**GARVEY COMMONS/
SHERBURNE HALL
ADDITIONS & REMODELING**
ST. CLOUD STATE UNIVERSITY
ST. CLOUD MINNESOTA

E-8

E-10

FIRST FLOOR PLAN - POWER & SIGNAL

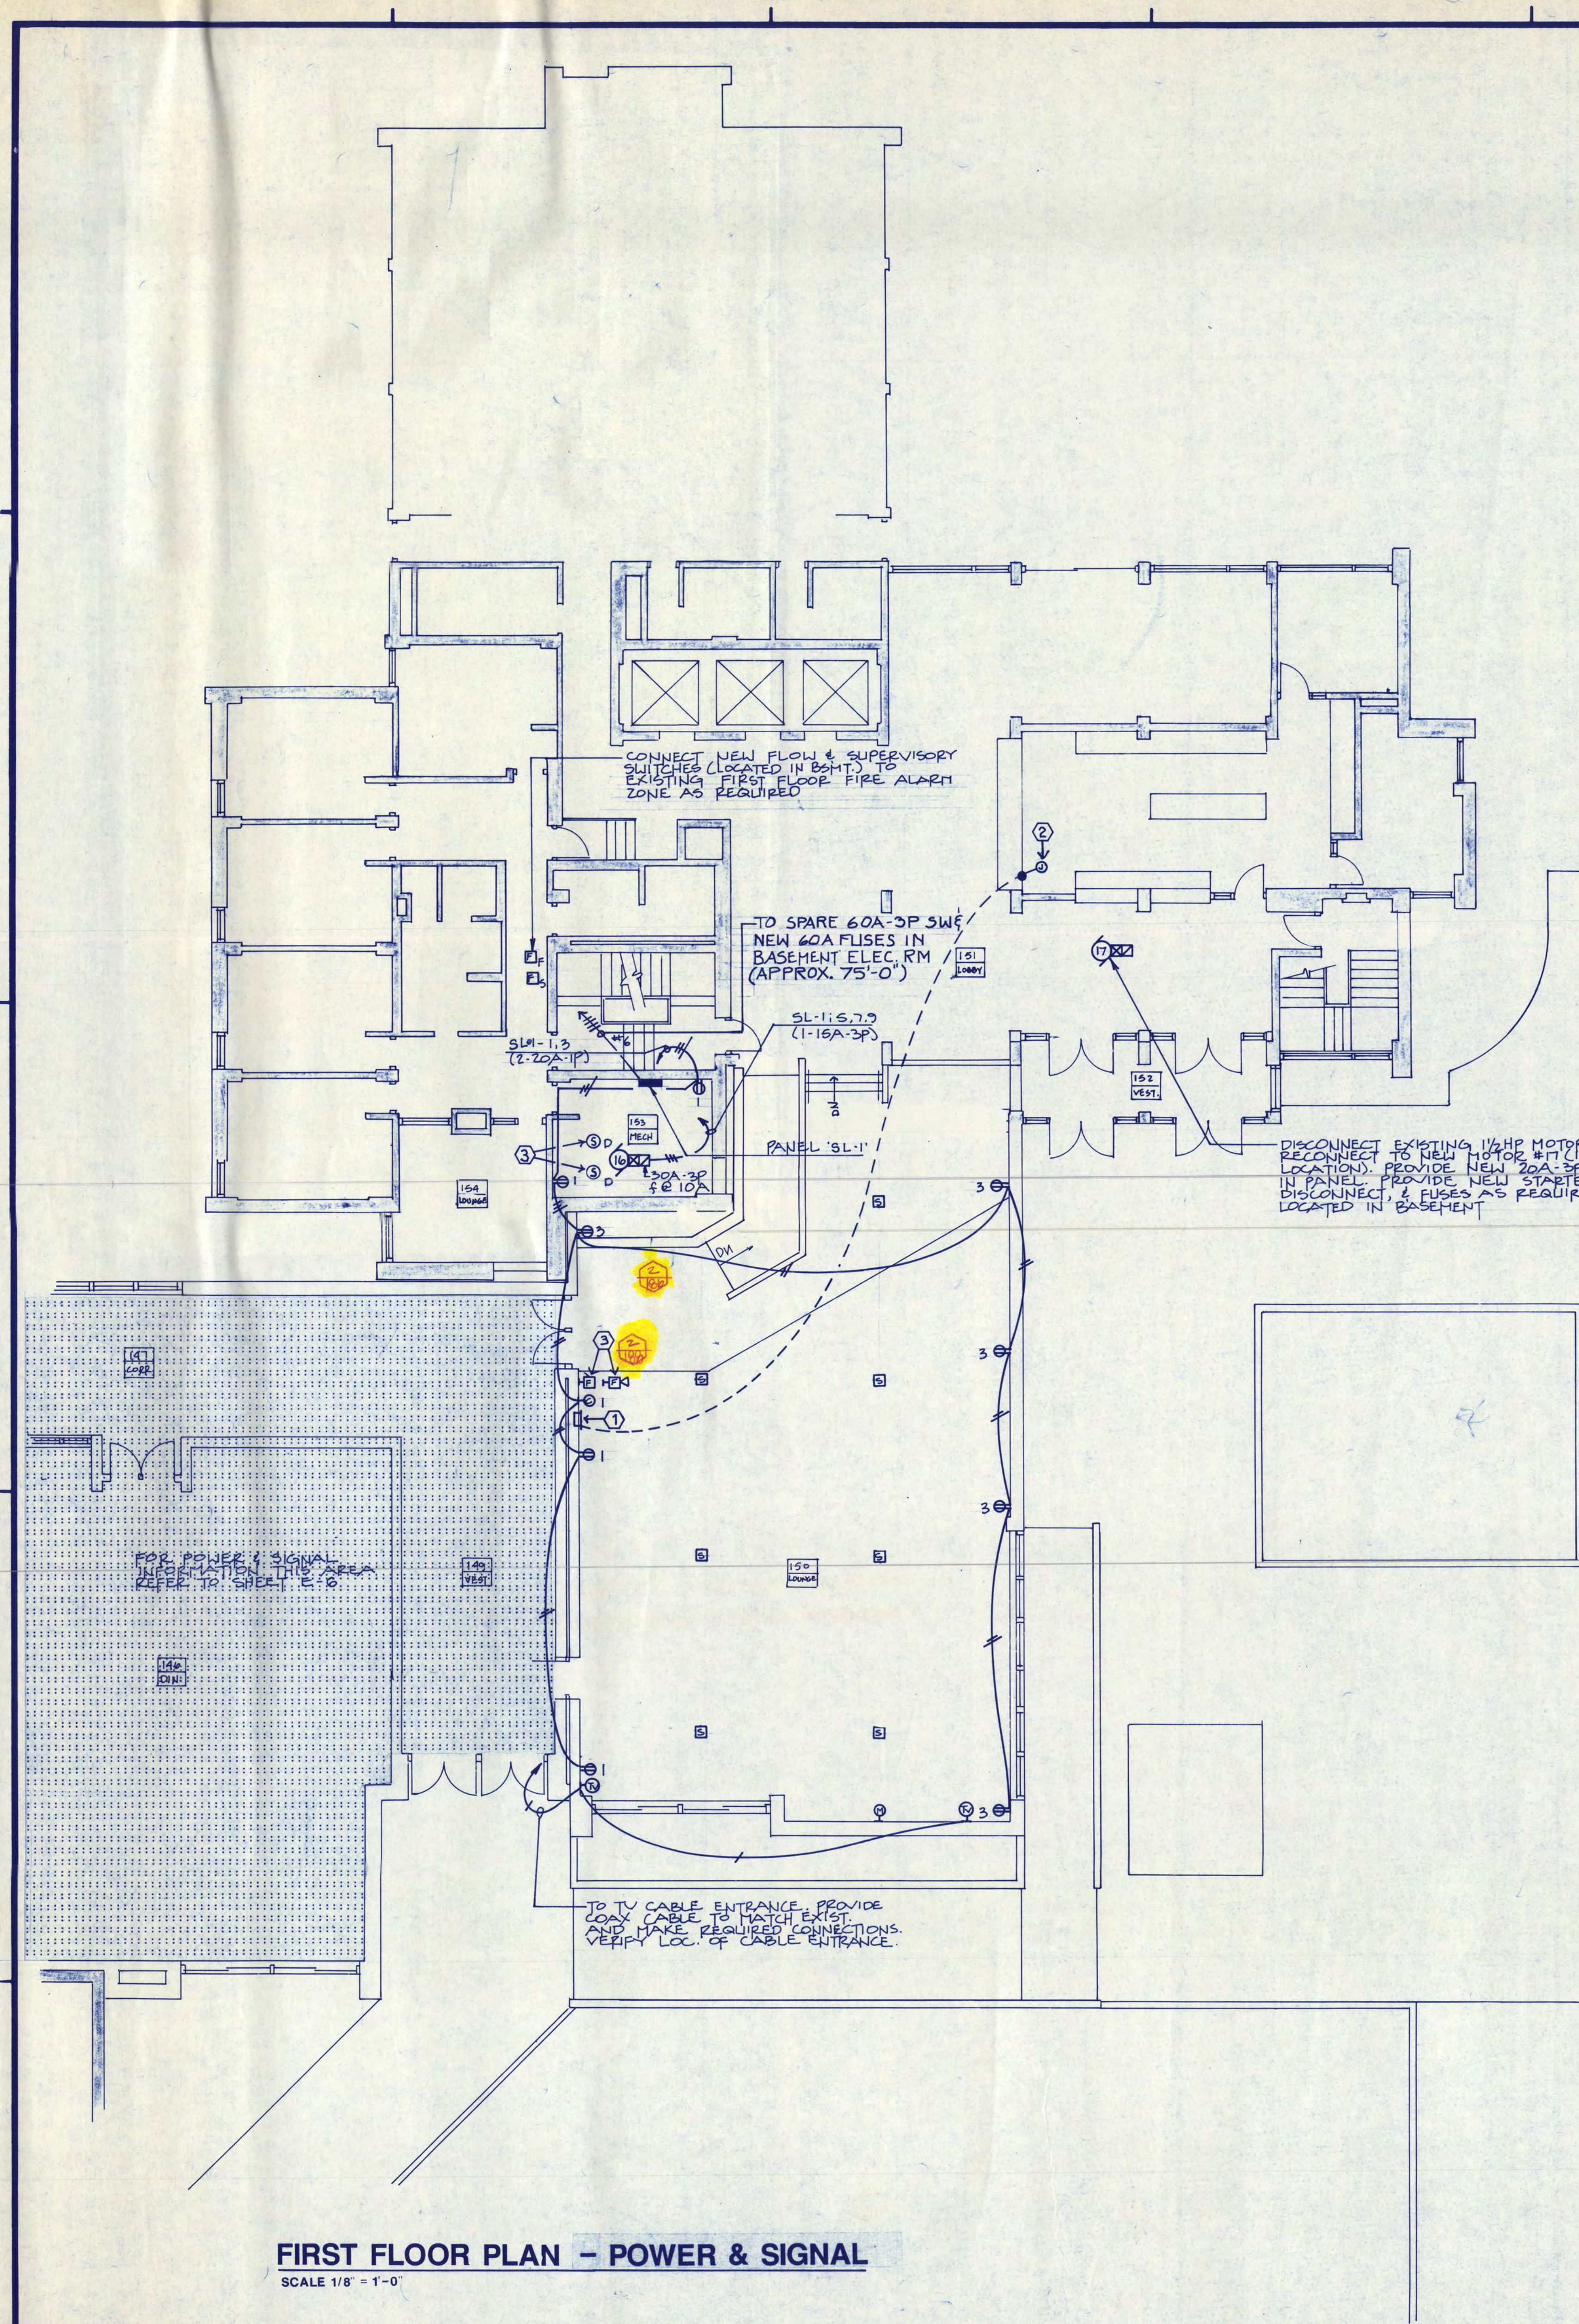
- 185. Add Electrical Note 4: Microphone outlet to be centered on east wall.
- 186. Reference Electrical Note 4 adjacent to microphone outlet on east wall of Room 150.
- 187. Add Electrical Note 5: Reuse existing audible alarm removed from Garvey Commons.
- 188. Reference Electrical Note 5 adjacent to fire alarm horn in Room 150.

PARTIAL PLAN-SERVING LINE & KITCHEN

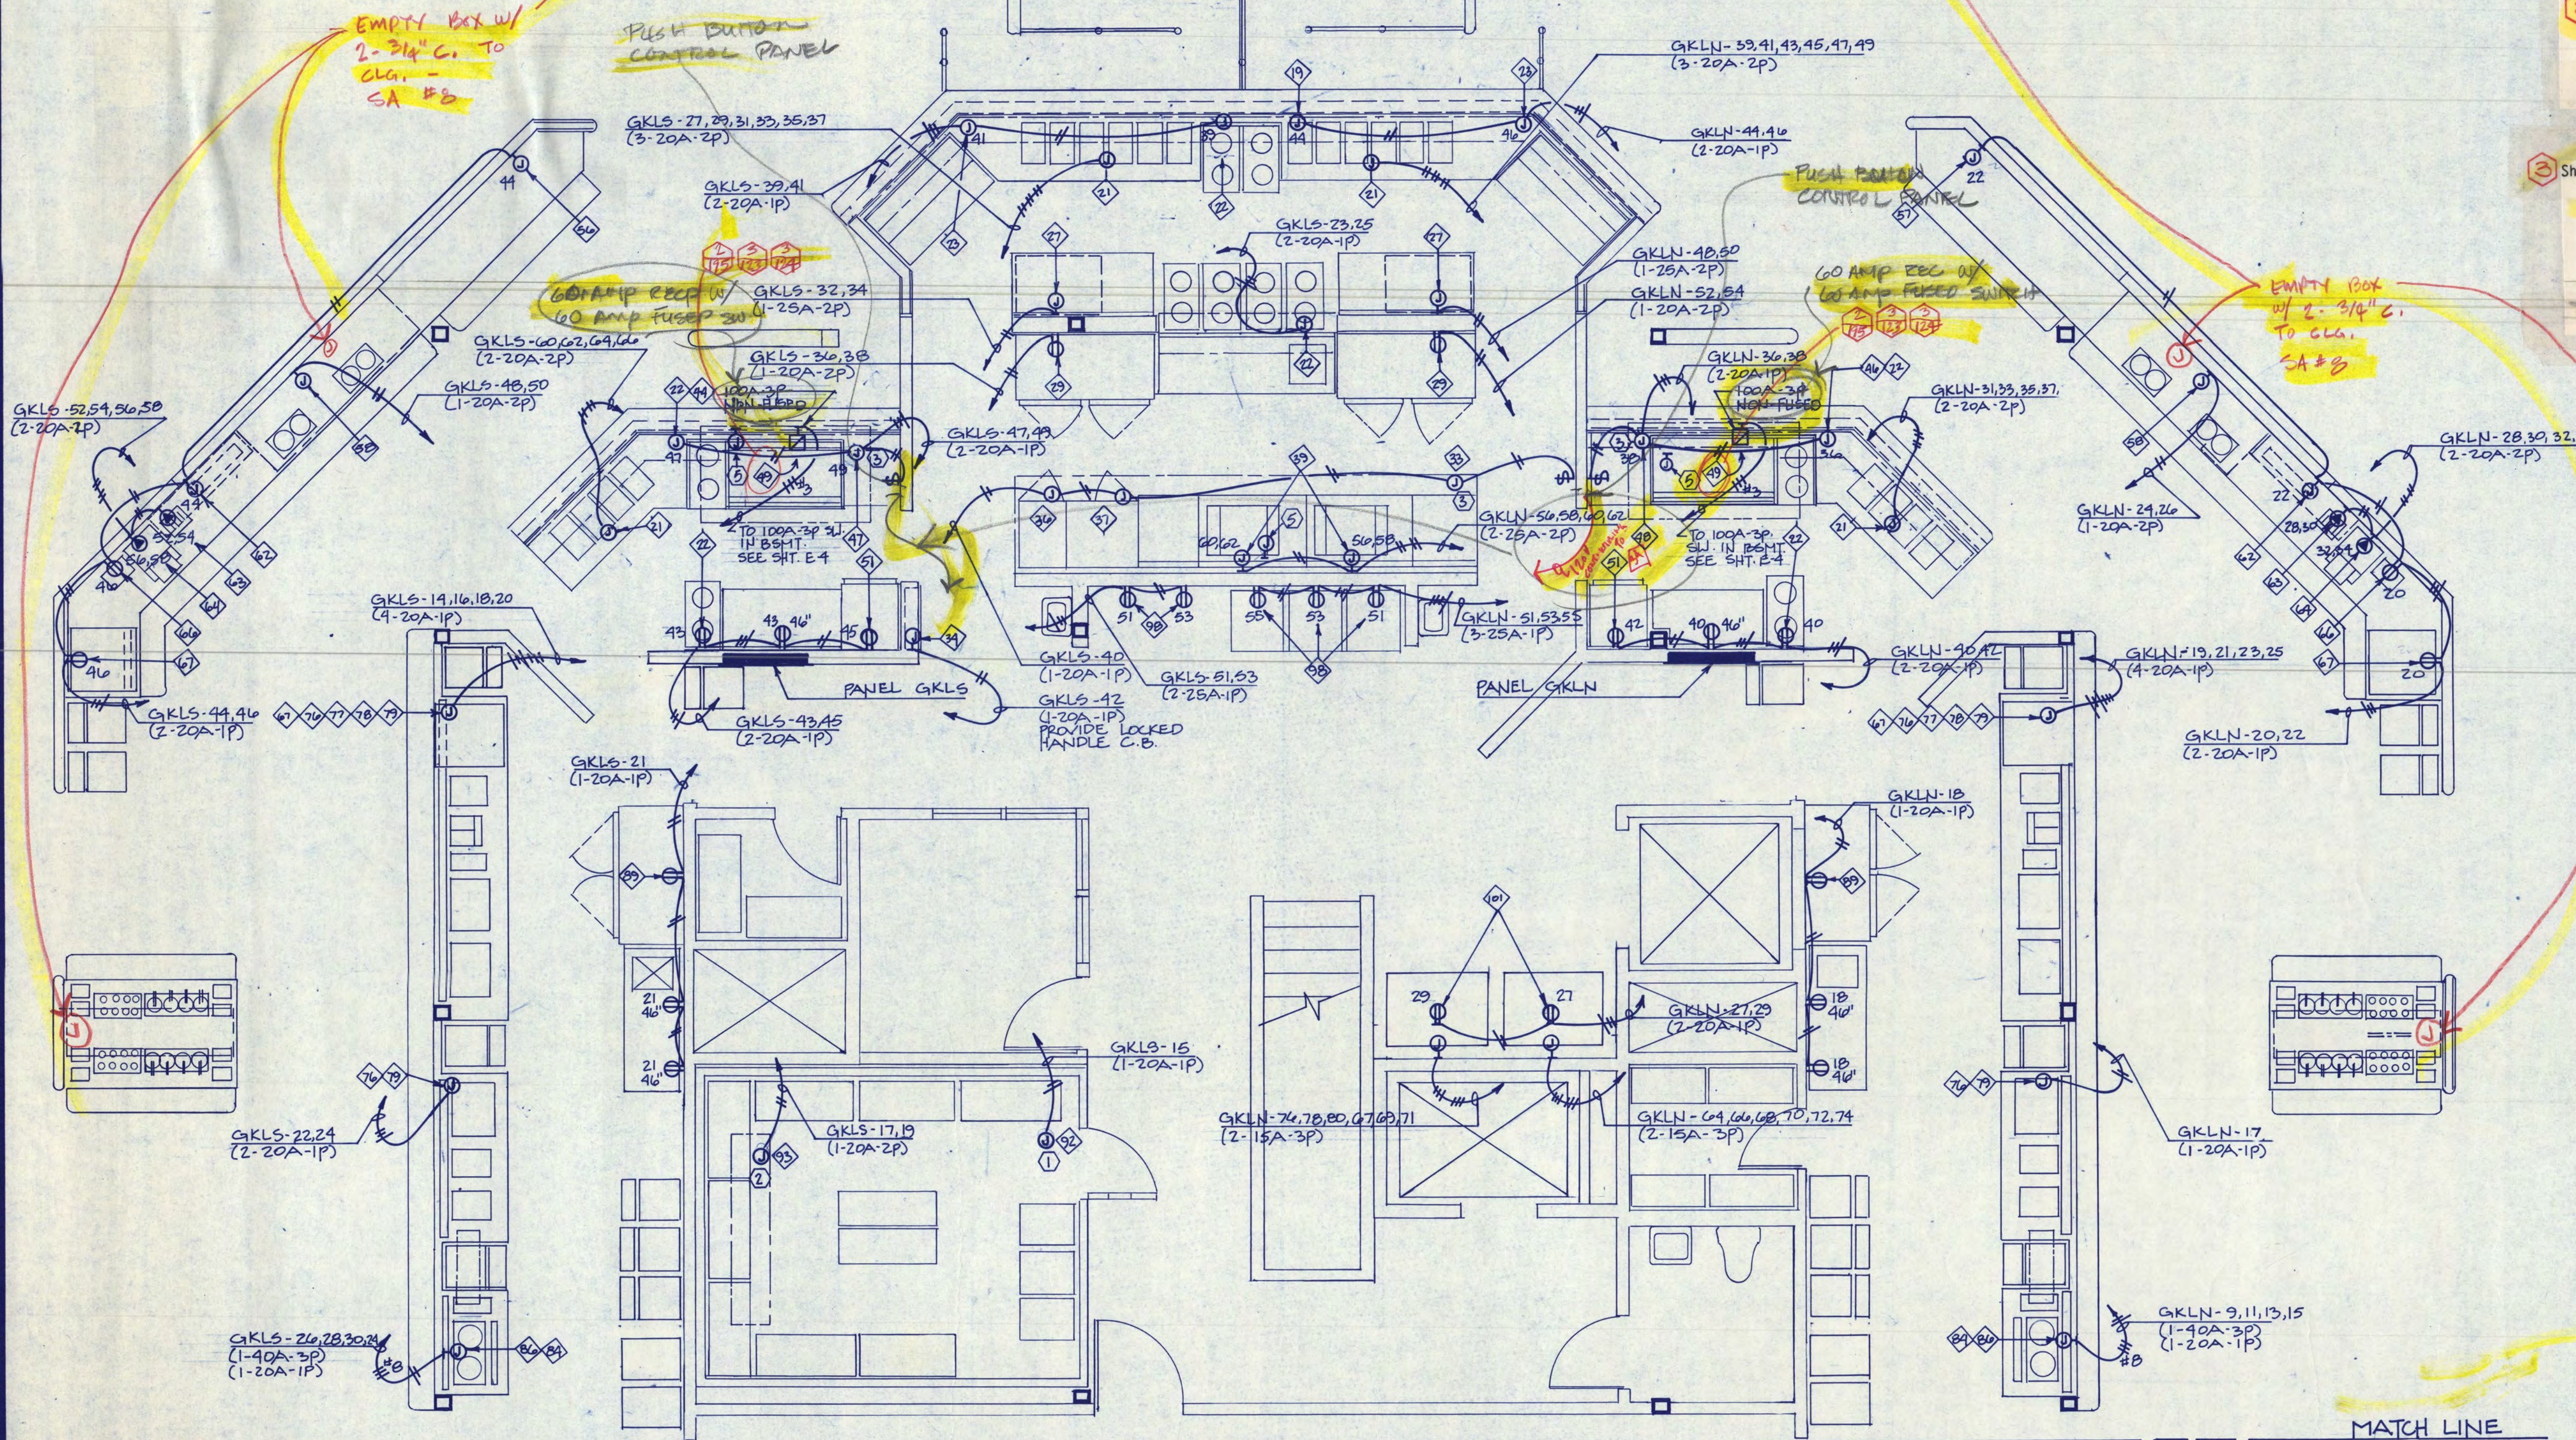
123. Add: Provide a 100 amp electrically held contactor in each 100 amp feeder to equipment #49, electrical grills. Provide with NEMA 12 enclosure. Locate with 100 amp switches in basement electrical room. Provide separate on-off pushbutton controls adjacent to each grill and 120 volt control wiring to item #34, fire protection system.

124. At each Item #49, add: Delete the 100 amp 3-phase non-fused switch; wiring to remain to serve 60 amp receptacles added by Addendum No. 2
